**EVALUATION OF HALTON REGION
LANDFILL TECHNICAL STUDIES
Site D - Milton**

HYDROGEOLOGIC REPORT

- **Part A - Definition of Hydrogeologic Suitability
for Landfilling**
- **Part B - Critique of Trow Technical Studies**
- **Part C - Interpretation of Site D Hydrogeology and
Suitability for Landfilling**

February 8, 1988

figure C3.1

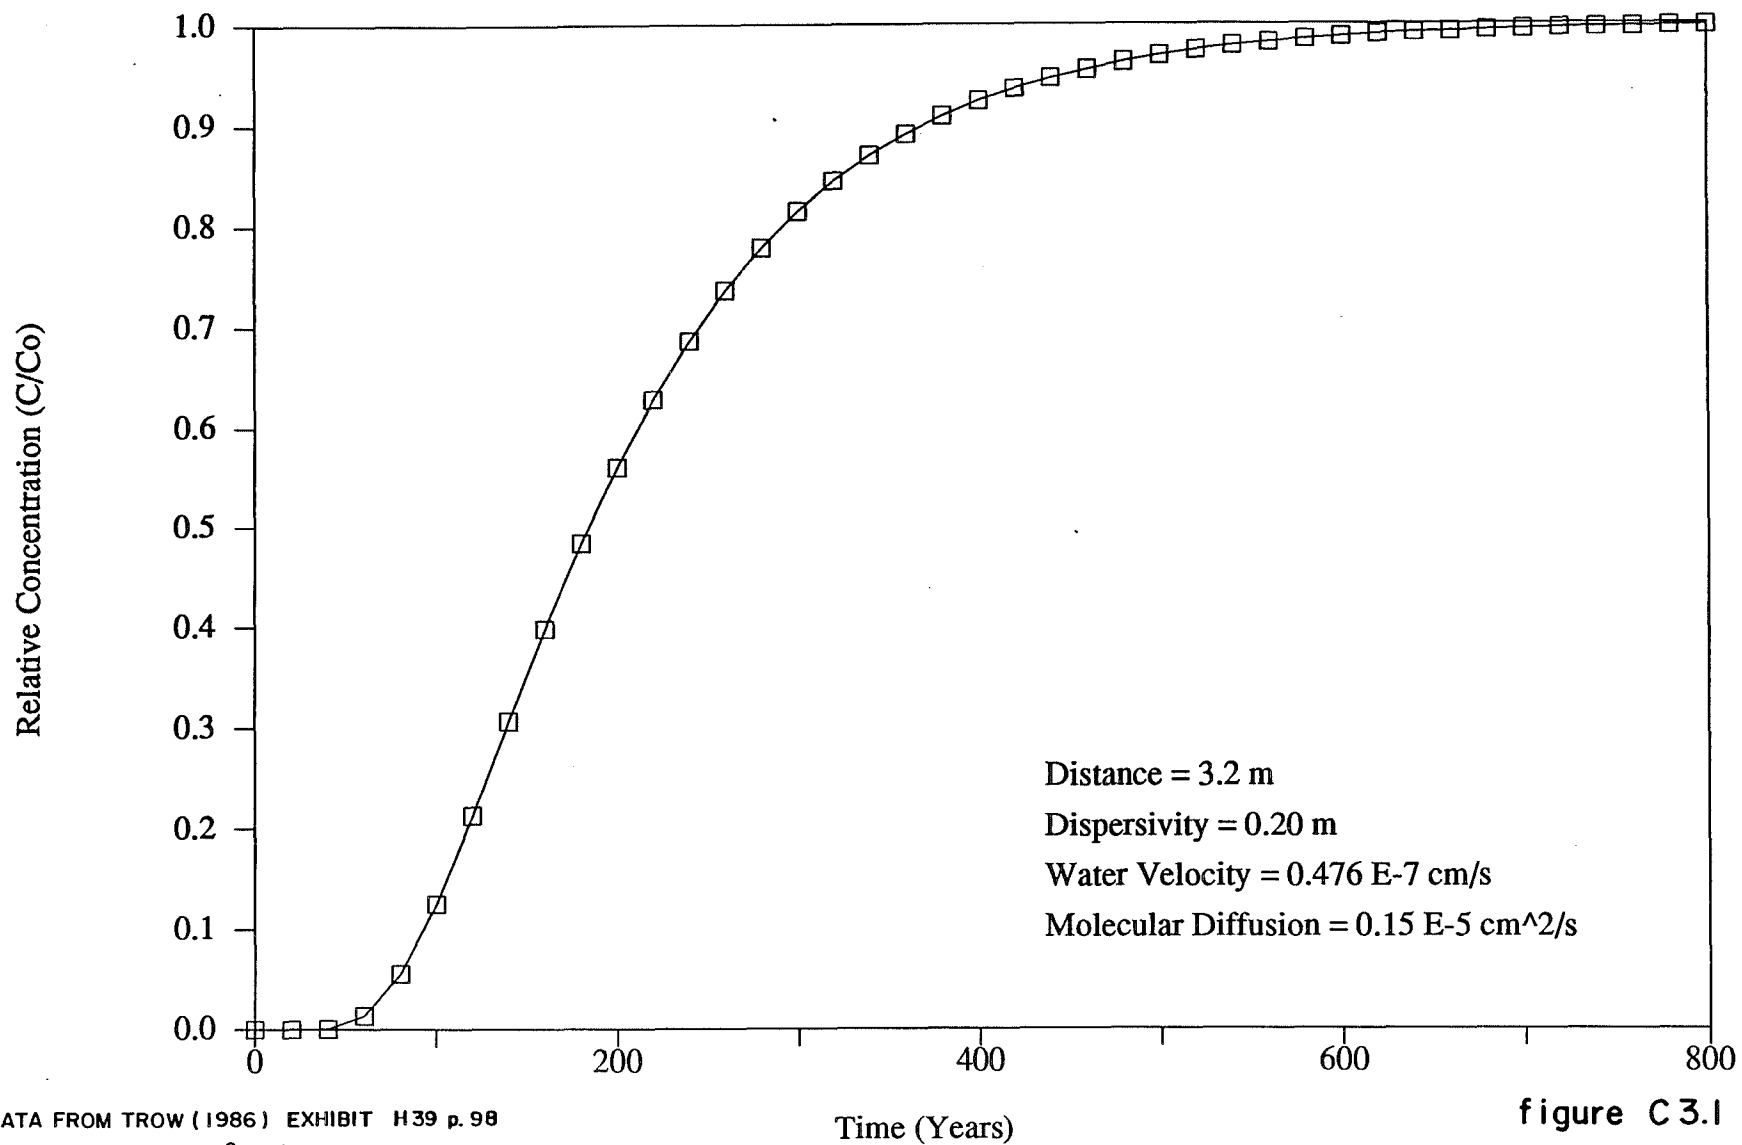
Ogata-Banks solution was again applied by CRA to estimate breakthrough times for contaminant transport through this till layer. The same dispersivity and molecular diffusion values as previously used by Trow were used while the groundwater velocity term incorporated the 1.4×10^{-8} cm/sec vertical hydraulic conductivity for the unweathered Upper Till. The resulting breakthrough curve is shown on Figure C.3.1 (p. 98). Again, this evaluation assumes that the hydraulic trap has failed and that no remedial measures are implemented.

By including the travel time for migration across the Lower Till as determined by Trow (25 years) (p. 99, Exhibit H-39) a total travel time of approximately 120 years is required for contaminants migrating downwards from the landfill at a concentration of one-tenth ^{one hundred} of that encountered within the landfill to reach the Upper Granular Unit.
